SERVICE BULLETIN

M-1018

NEUTRAL SWITCH – ALL MODELS

Neutral Switch Comparison

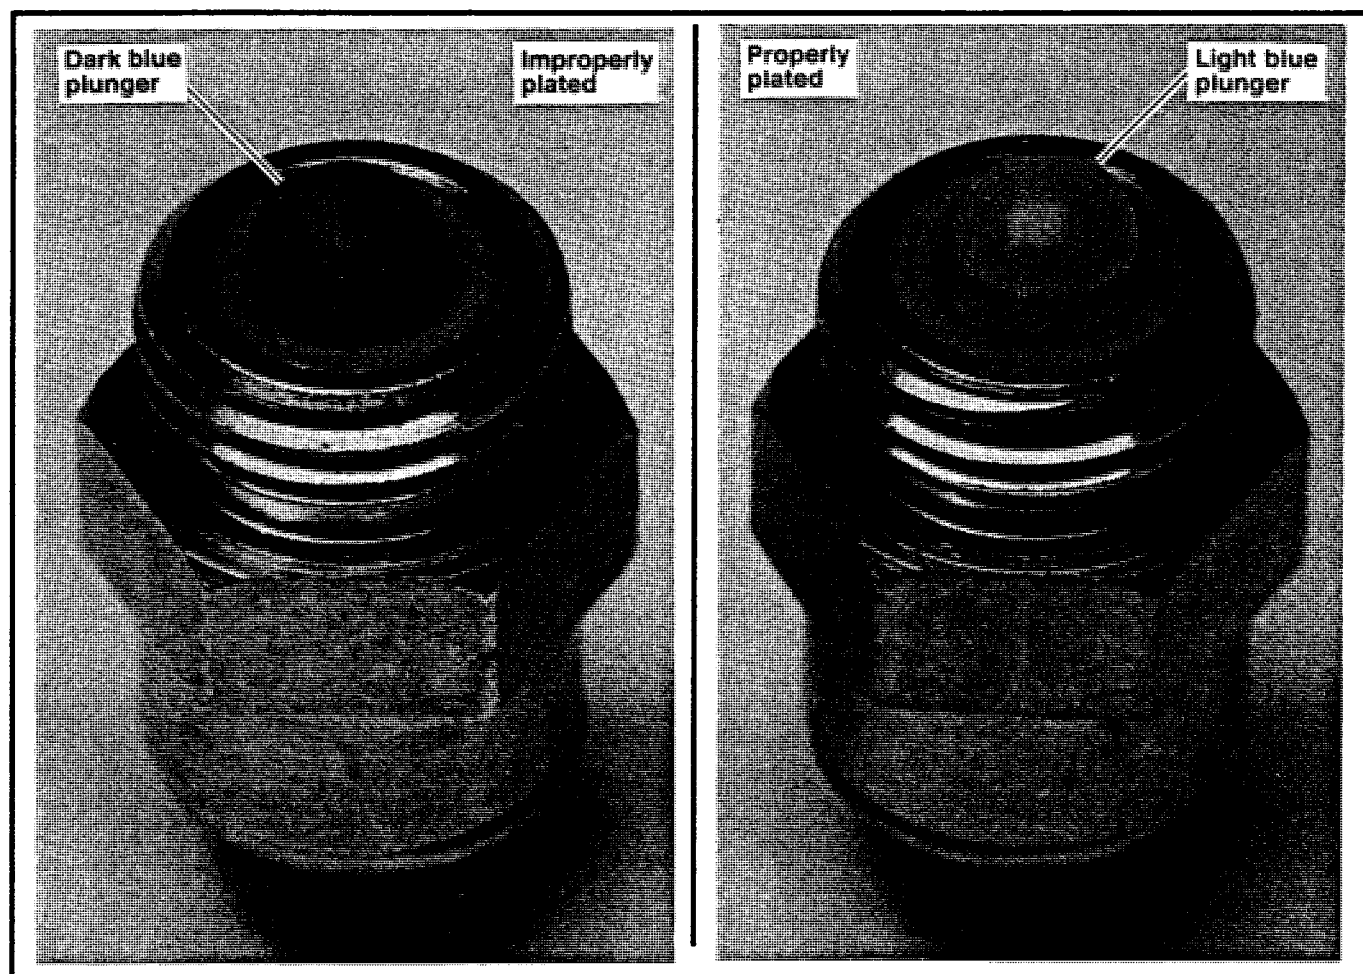
In 1992, as a product improvement, Harley-Davidson increased the hardness of the plunger in the neutral switch. On a certain number of switches, the plunger plating was done improperly.

Motorcycles produced between Monday, September 9 and Wednesday, October 2 may have the switches with improperly plated plungers installed.

Because of this condition, some of your customers may experience a flickering or no neutral indicator lamp when they shift their motorcycles into neutral.

See Illustration. The switches with improperly plated plungers can be identified by a very dark blue, almost black, plunger. Properly plated plungers have a light blue appearance.

Harley-Davidson will warranty replacement of the incorrectly plated switches. If your customer complains of a flickering or no neutral indicator lamp, the switch should

be replaced. If you have these switches in stock, replace them also. Follow normal warranty procedure.

The new switch, Part No. 33900-59A, can retrofit vehicles built before 10/1/91. The old switch, Part No. 33900-59, must not be used on vehicles built after 10/1/91. The purpose of using the light blue plunger is to easily identify the new switch.
